INDOOR AIR QUALITY [IAQ] EVALUATION AND HVAC SYSTEM ASSESSMENT

Madison Neck River Elementary School

Prepared for:
Peter Anderson
Director of Facilities Madison Public Schools

Kohler Ronan Project #26065

SHEET NO. 51R

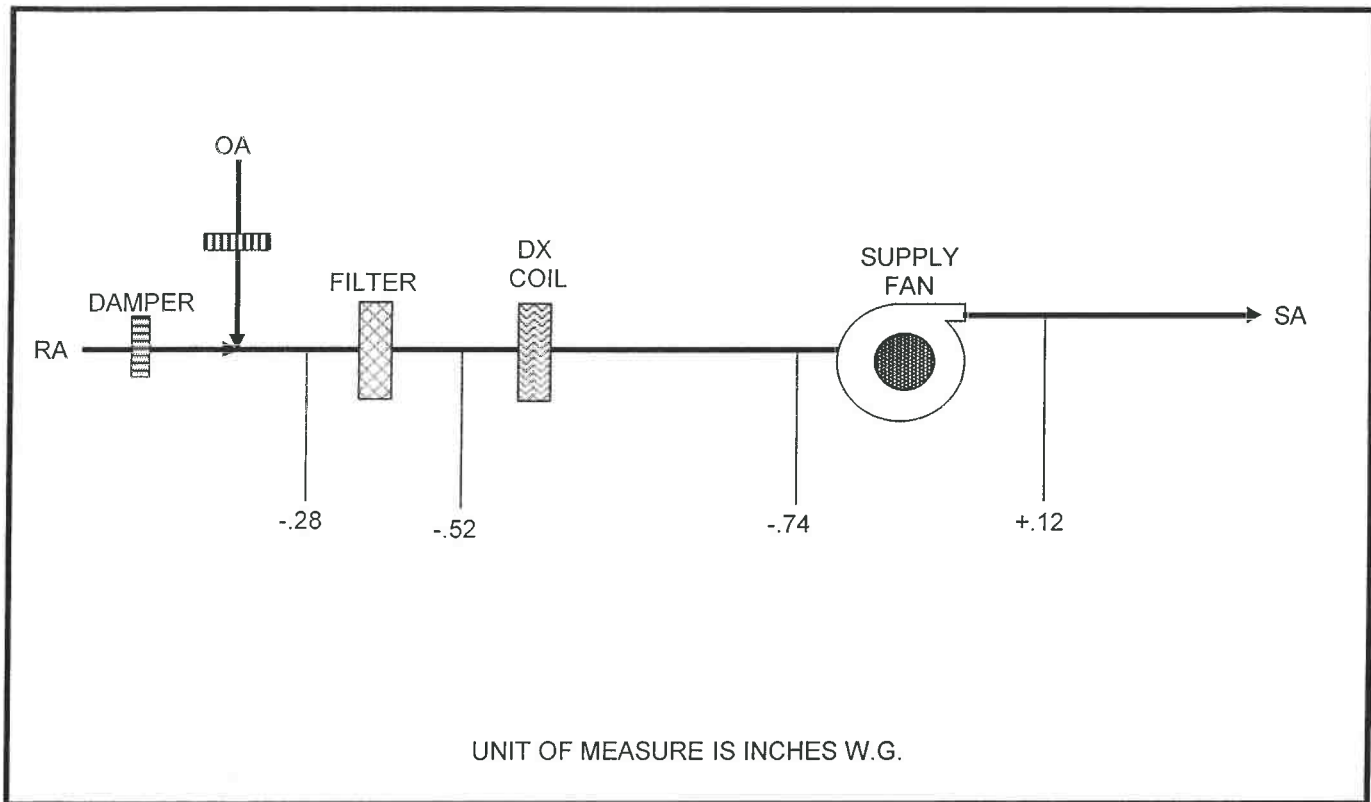
GBC: Update values per findings recorded during April 2026 visit

SHEET NO. 53R

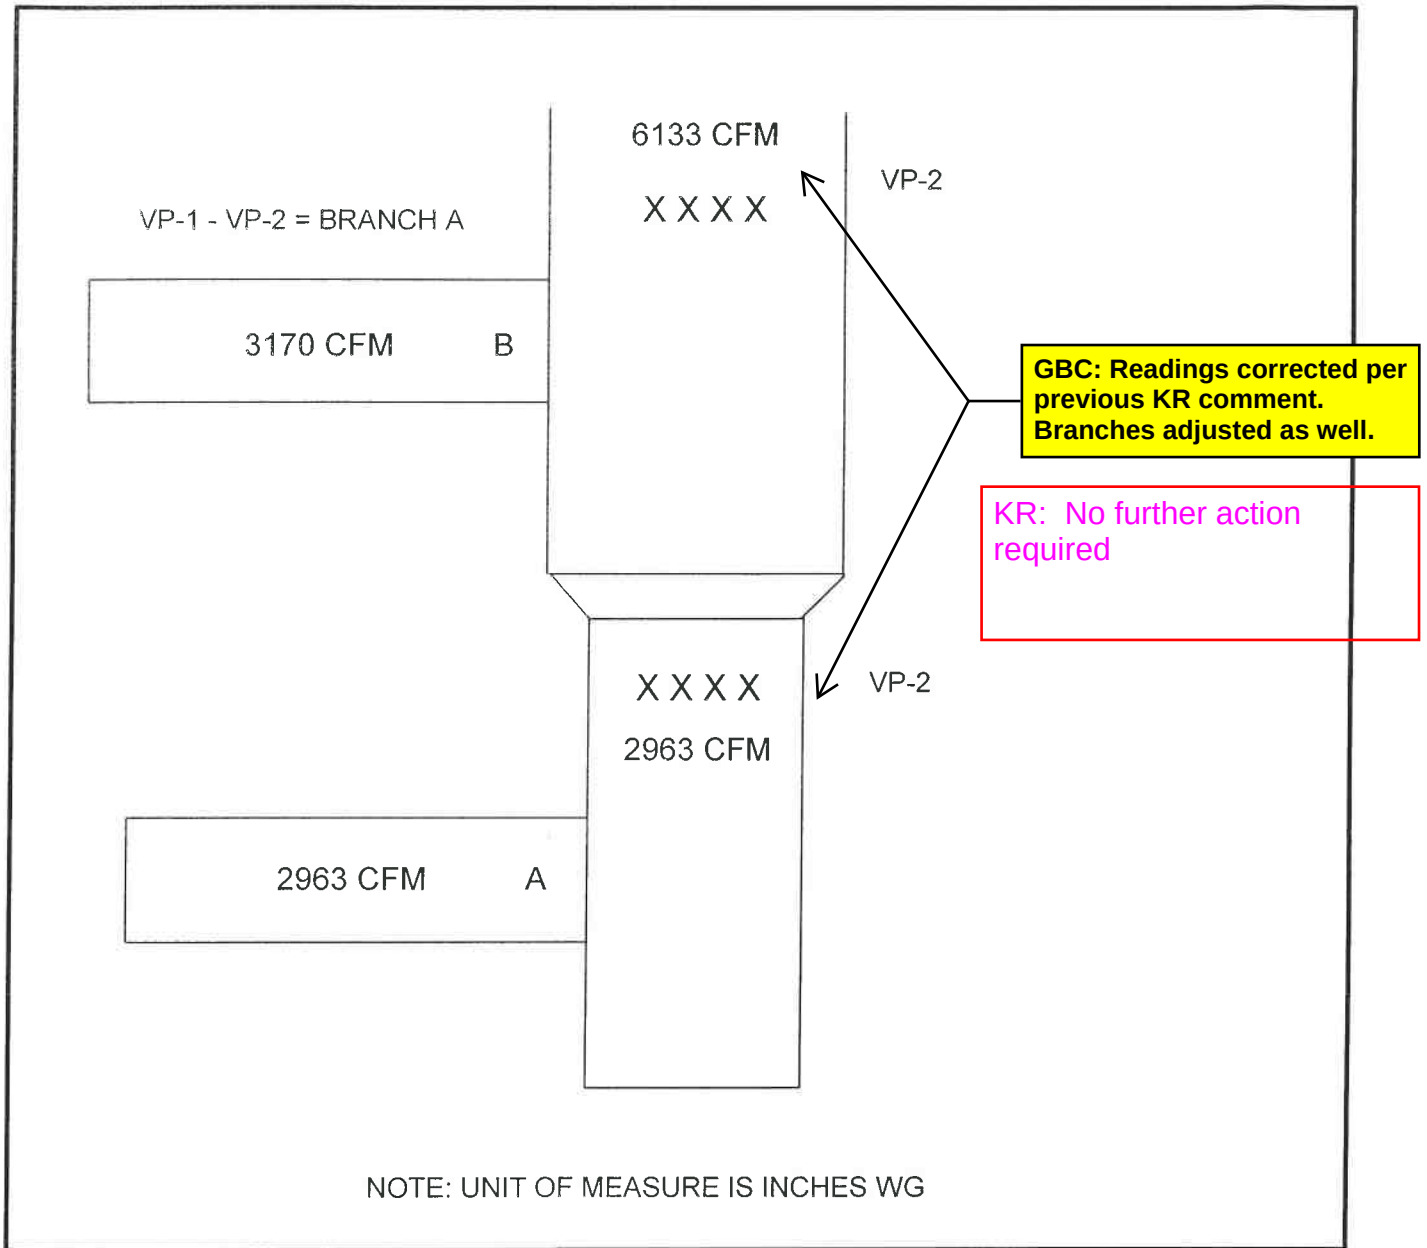
GBC: Sheave replaced in April 2026

GBC: Updated April 2026 readings are notably closer to design values.

KR: No further action required

GBC: Updated readings taken in April 2026 align with HP-M-1.
